<b>SAFETY NOTICE</b>	<b>SN732</b>
<b>NHTSA Recall No.</b>	<b>24V-740</b>

**MODELS AFFECTED: TM, TL80, TL80/112, & TL 100 Aerial Devices**

**SUBJECT: Jib Extension Cylinder Rod Weld**

Figure 1. Example Hydraulic Cylinder Date Code

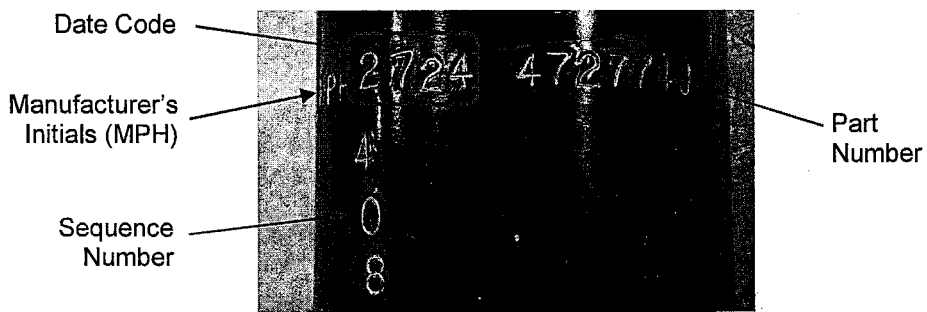
1. Any MPH hydraulic cylinder with part number 472774 and date codes and sequence numbers shown in the table below stamped in the case is subject to the recall and will need the hydraulic cylinder replaced.

Terex will replace the affected hydraulic cylinder for any unit involved in this recall at no cost to the owner. The availability of replacement cylinders will be communicated once determined.
